REQUEST FOR INFORMATION (RFI)

RFI No.: ABF-RFI-003204R00 **Submitted By:** OSullivan, Bill **Pages:** 2
Pages Attached: 1

Subject: Hinge AW, AE: Electrical	
References:	
Sub/Sup: BLI	**Sub RFI #:** RFI-BLI-000170R00
Response Required by: 28-February-2013	**Response affects critical path activity?** Yes

Project: 04-0120F4 - SAS

SK-RFI3204-04

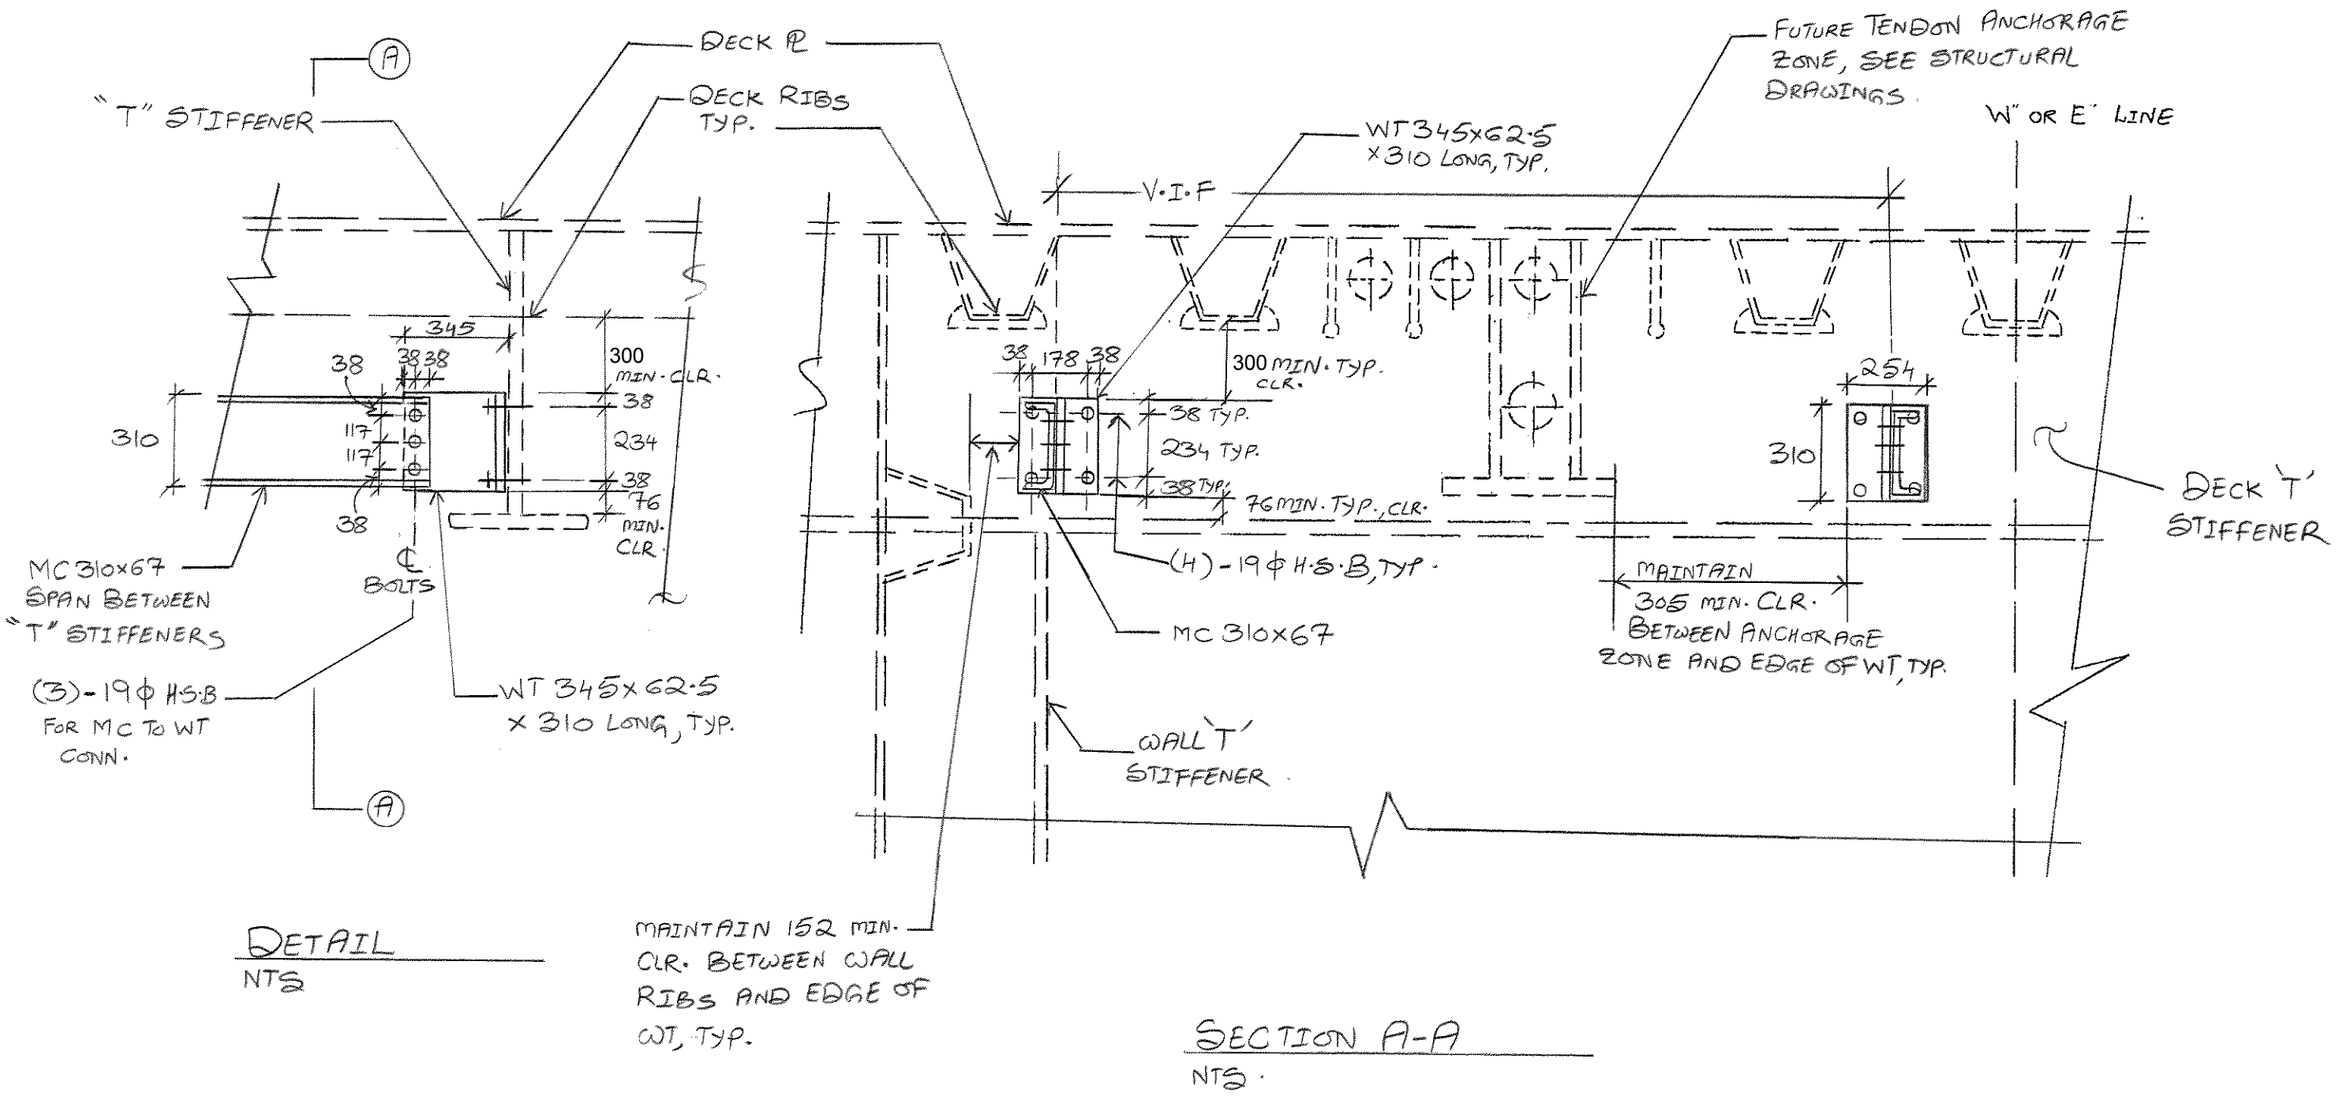
d) Detail 1 shows structural channel C100x8. Contractor is requesting information for attachment of the channel to the OBG ceiling. Contractor is requesting clarification for the quantity of channels indicated as five (5) on the contract plan sheet.

1d. Conduit and cable tray support at Hinge A and attachment of cable tray hanger supports to the OBG structure has been revised. Please find attached sketches SK-RFI3204-E132A/221A, SK-RFI3204-03 thru SK-RFI3204-05 for details.

d) Attached sketches SK-RFI3204-E132A/221A, SK-RFI3204-03 thru SK-RFI3204-05 provides revised details for conduit and cable tray support at Hinge A and attachment of cable tray hanger supports to the OBG structure.
